# Gas Industry Standards Board

**TO:** Executive Committee  
**FROM:** Rae McQuade, Executive Director  
**RE:** Supplemental Materials for the Executive Committee Meeting on February 12, 1998

Re: Amoco Comments to Clean-up Intraday Package for Feb 12 Mtg

RE: Amoco Comments on Intraday Package due GISB by Jan. 16

# PROPOSED STANDARD 1-1-X Timely Nomination/Intraday Nomination Model

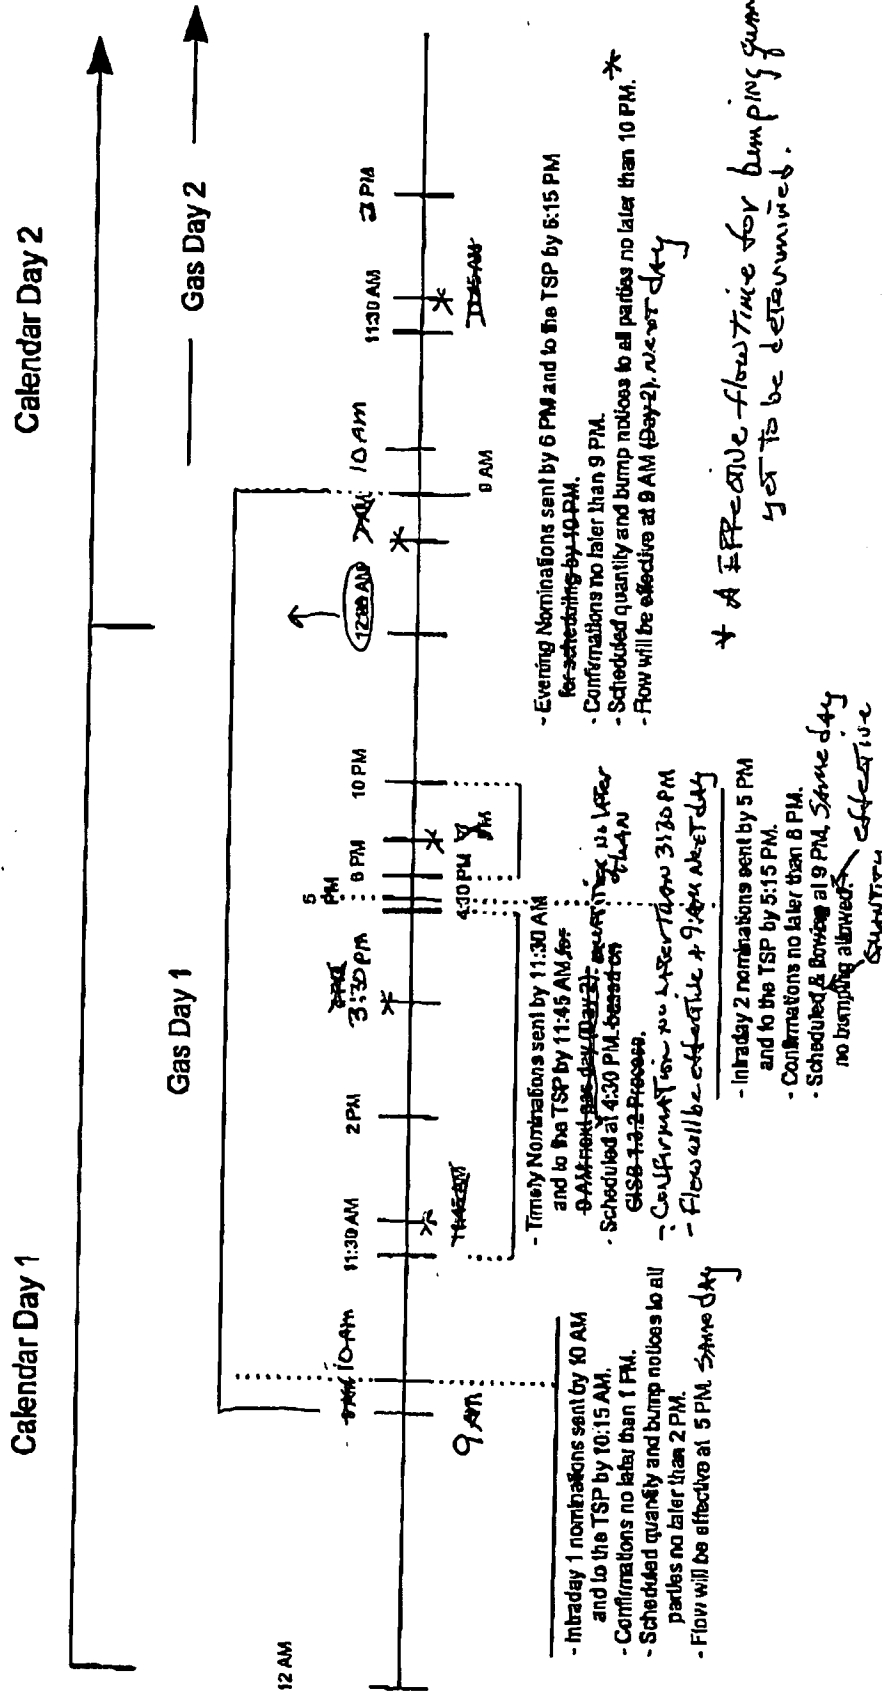
Model Drawing - There is a lot of clean up necessary to make the model consistent with the standards. The heading needs a rewrite. The timeline should be calibrated properly and labelled consistently. There are word changes as well. (See my fax copy)
